CITY OF ALBUQUERQUE

RE: **Mountain Subdivision**
2406 Mountain Rd NW
Grading Plan Engineer's Stamp Date: 1/8/18
Drainage File: J13D207

Based on the information provided in your submittal received 1/10/18, the Grading Plan cannot be approved until the following are addressed.

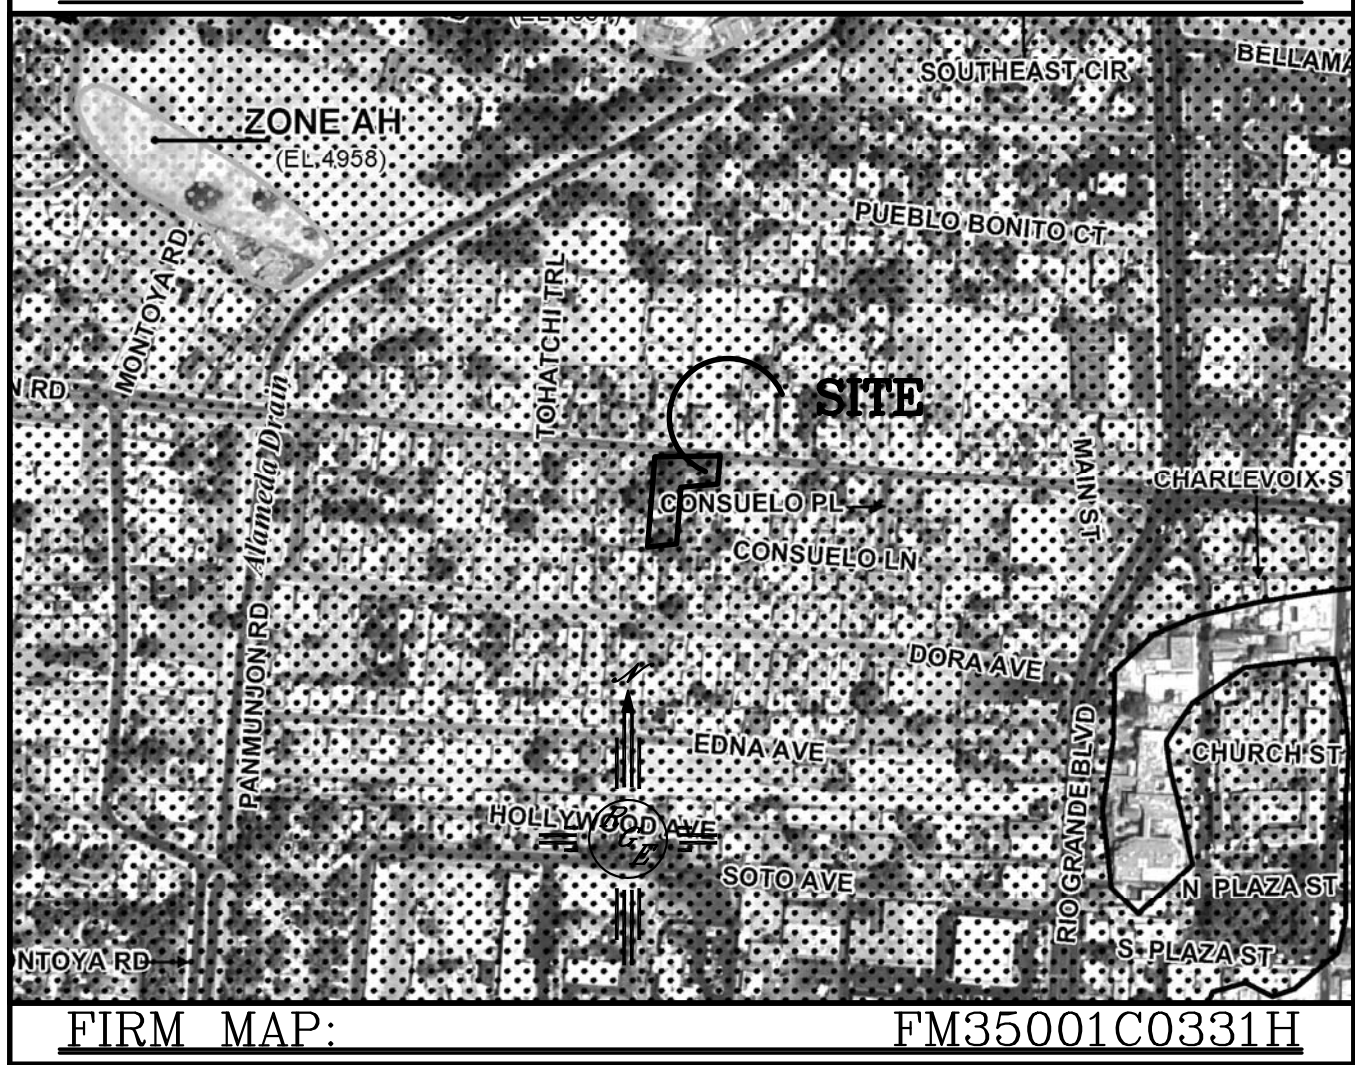
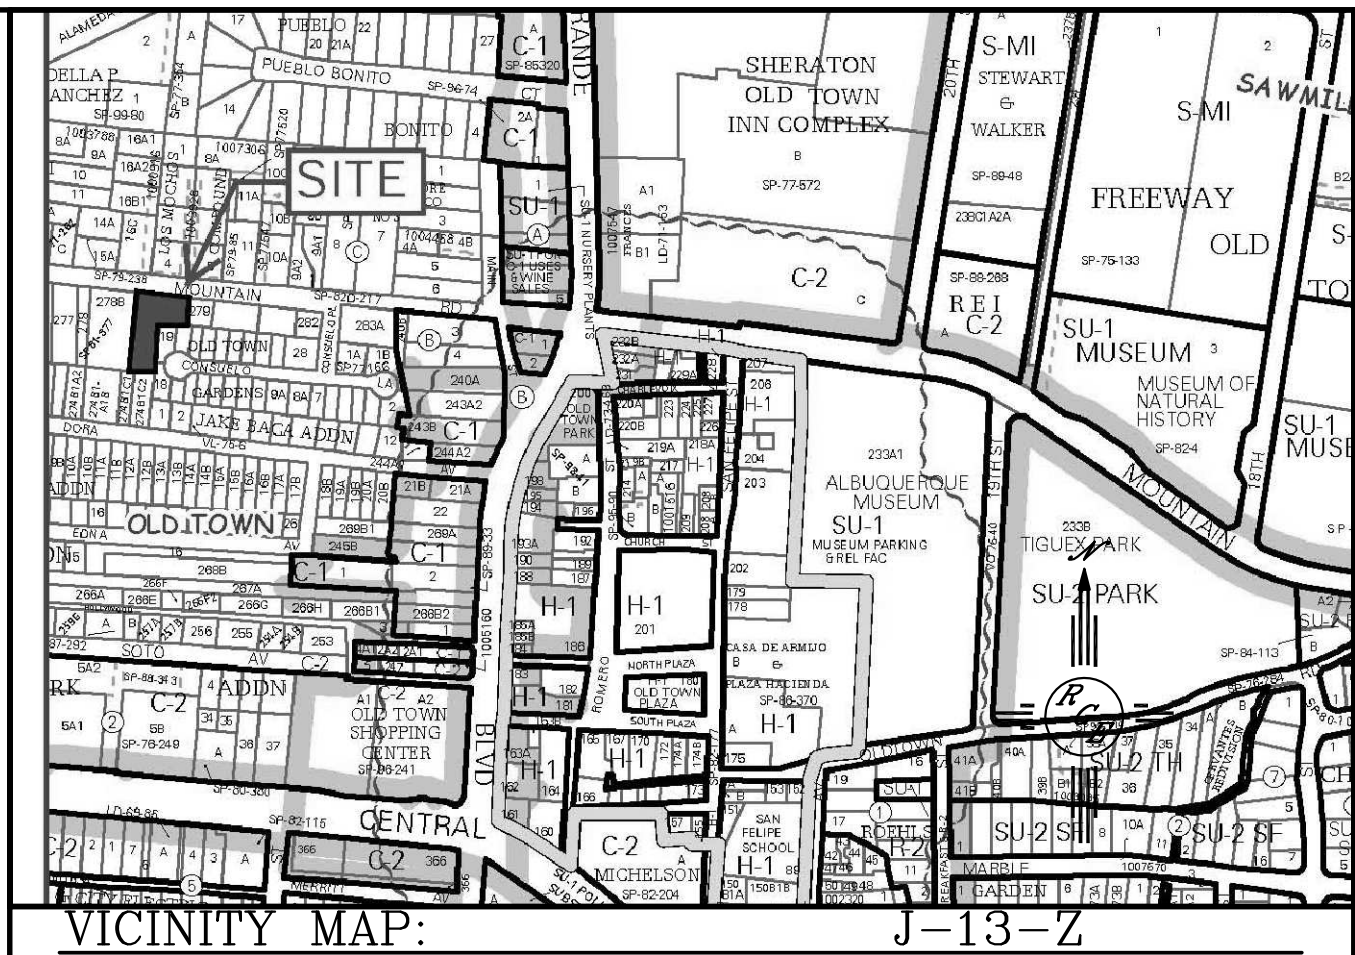
1. Provide onsite ponding volume on each lot for the 100-year, 10day volume; infiltration rates cannot be accepted in lieu of this volume requirement.
2. Please add swales along the side yards to direct runoff into the ponds.
3. Ensure that the Preliminary Plat includes cross lot drainage easements identifying maintenance and beneficiary responsibilities to support the ponds crossing the lot lines.
